MDL02_Noise_Assessment.docx
EN02239.200

Re: Tallawarra Lands Noise Assessment

Further to our meeting on Tuesday 31 January 2012, this letter addresses noise issues raised in letters by DoPI (23 December 2011) and OEH (7 November 2011) relating to the Tallawarra Lands project.

Attachment A Northern Precinct Lot Layout

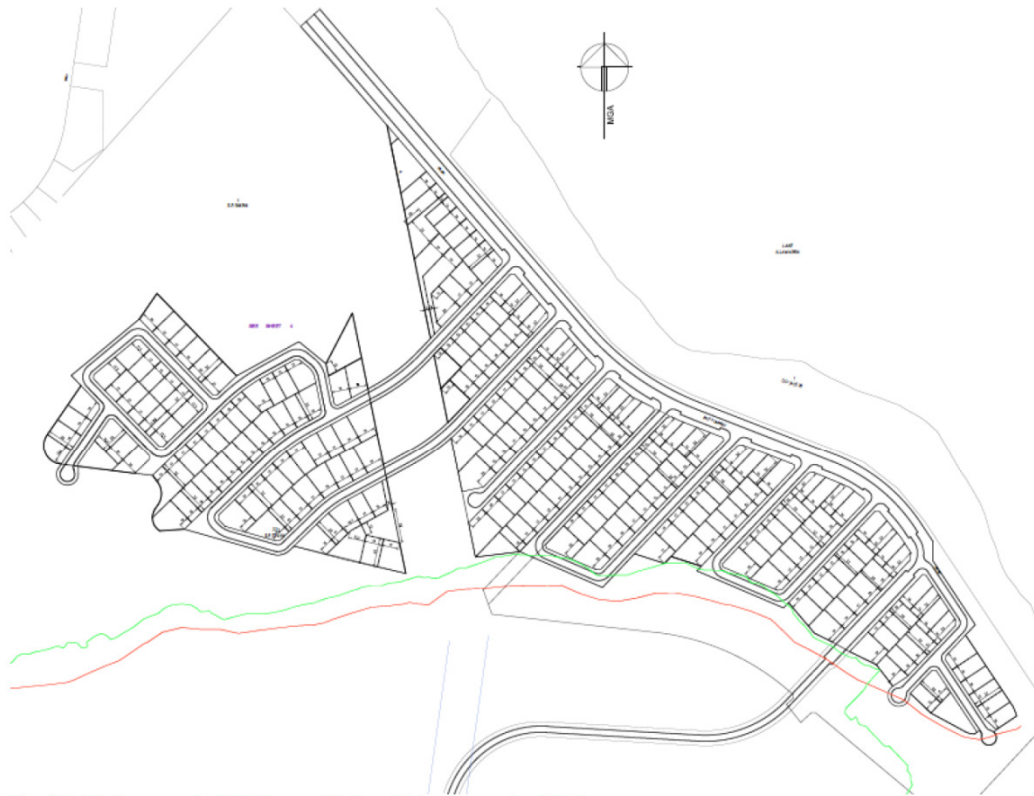
- DoPI letter (23 December 2011) -Schedule 1 (page 2) Residential Amenity – Noise:
 - *Paragraph 1, 2 and 3: DoPI express concern at potential exceedances of noise criteria in the Tallawarra Lands of up to 5 dB(A) from the power station (Tallawarra A and B).*

- **Land Use Planning Controls:** *OEH express concern at the reliance on building design within the Tallawarra Lands residential areas to meet noise criteria outlined in the Tallawarra B approval.*

In response to this issue, TRU energy has revised the lot layout for the northern precinct residential area, such that all residential lots are now located outside of the criteria 40 dB(A) LAeq and 50 dB(A) LAmax noise impact zones (refer to **Attachment A**). That is there is not predicted to be any exceedance of external noise criteria within the Tallawarra Lands from power station noise.

As per response to DoPI letter page 2 para 1, as above – TRUenergy have revised the lot layout for the northern precinct residential area, such that all residential lots are now located outside of the criteria 40 dB(A) LAeq and 50 dB(A) LAm_{ax} noise impact zones (refer to **Attachment A**). That is there is not predicted to be any exceedance of external noise criteria within the Tallawarra Lands from power station noise.
